Stage 1 Road Safety Audit

**Proposed Residential Development,
Kingston Lands, Kingston Road, Galway**

On behalf of **Kingston Stables Ltd**

September 2025

3.2.5 Cyclists Junction Visibility – Kingston Road

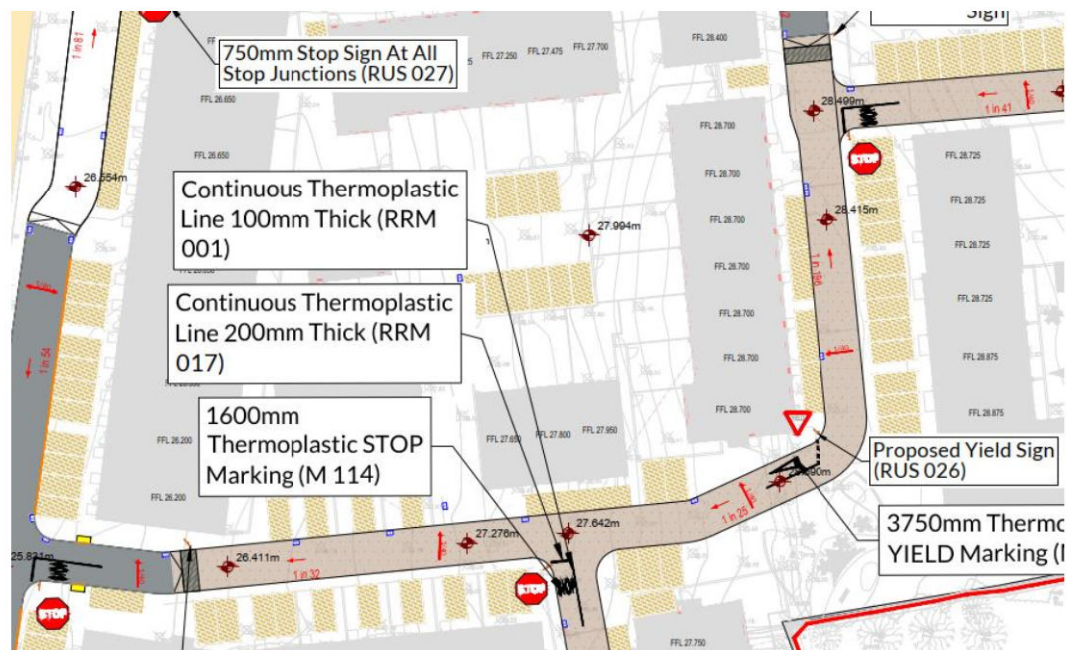
Problem: Cyclists from the development have visibility onto Kingston Road restricted in both directions by boundary walls and vegetation.

Hazard: Cyclists may exit the development junction into the path of oncoming vehicles, cyclists or pedestrians.

Recommendation: The Design Team should ensure cyclists visibility is achieved to both the carriageway and footpath.

3.2.8 Active Travel Path – Gradient

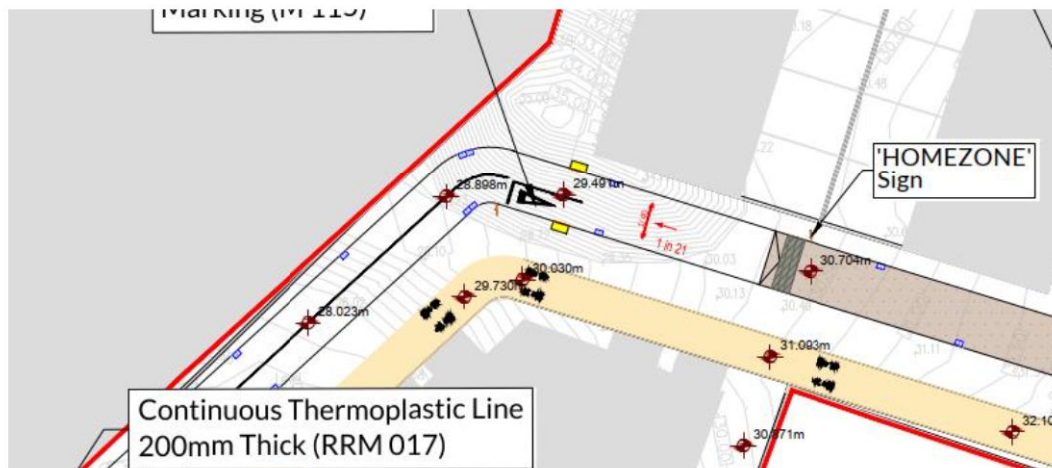
Problem: There is a section of active travel path that appears to be to a steep gradient. The design incorporates switch-back ramps in order for users to navigate the gradient. This will require cyclists to both travel down a steep ramp and also undertake a 90-degree turn at the bottom of the ramp.

Hazard: Cycle loss of control may result in falling from the bike or impact with opposing pedestrians / cyclists.

Recommendation: The Design Team should redesign the area to achieve a path that is safe for cyclists and pedestrians to use.

3.2.10 Termination of Active Travel Path

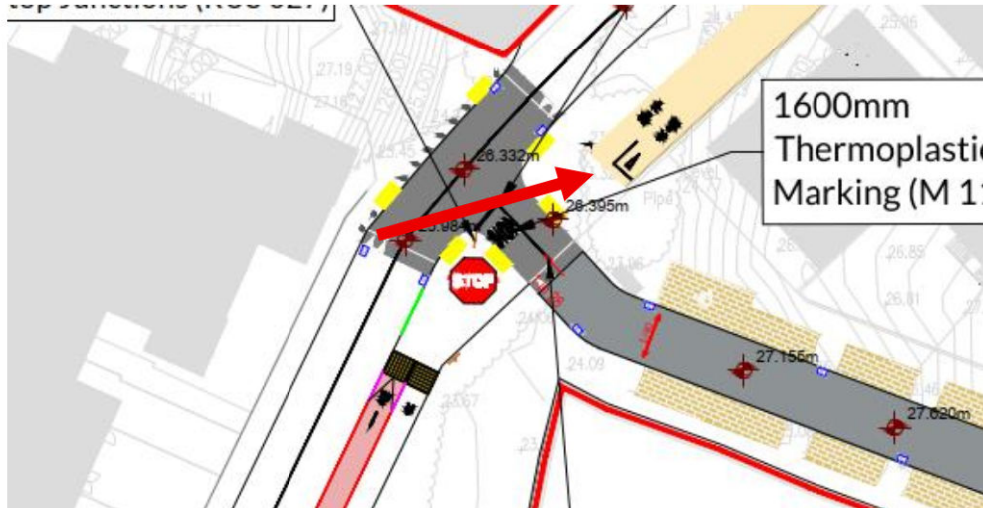
Problem: It is not clear from the design what the cyclists is meant to do at the start and end of the active travel path.

Hazard: Cyclists may cut in front of motorists vehicles when leaving / rejoining the carriageway. Impact between users may result.

Recommendation: The Design Team should redesign the start and ends of the active travel path in order to accommodate a safe transition to/from the carriageway for cyclists.

3.2.11 Footpath Widths

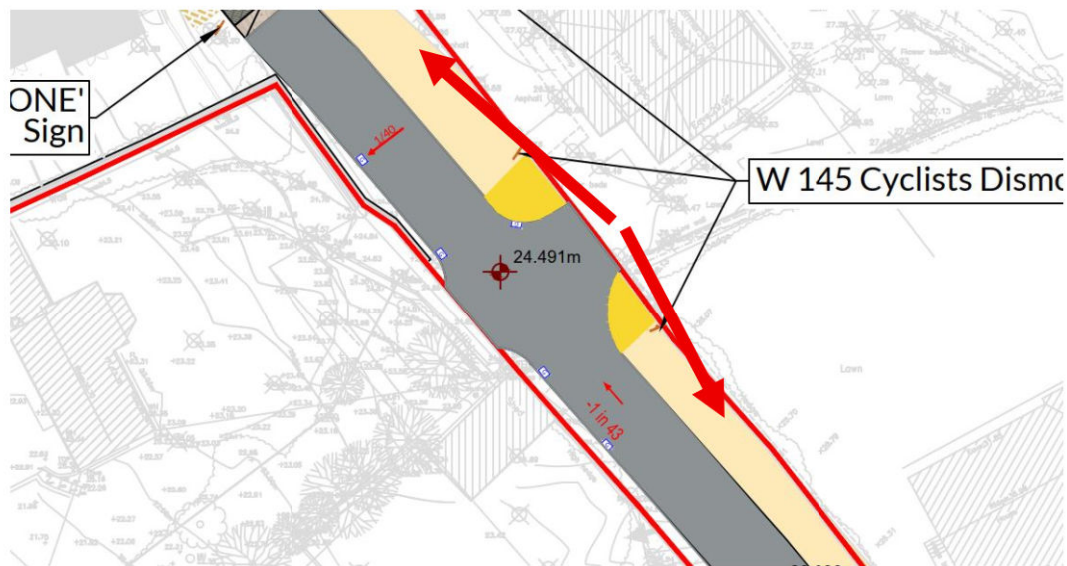
Problem: The footpath space between parked vehicles and buildings appears to be very narrow. Wheelchair users may have difficulty in passing through this space and may attempt to walk.

Hazard: Trip / fall injuries may result.

Recommendation: The Design Team should ensure all accesses to the dwelling units can be comfortably achieved for wheelchair and mobility scooter users.
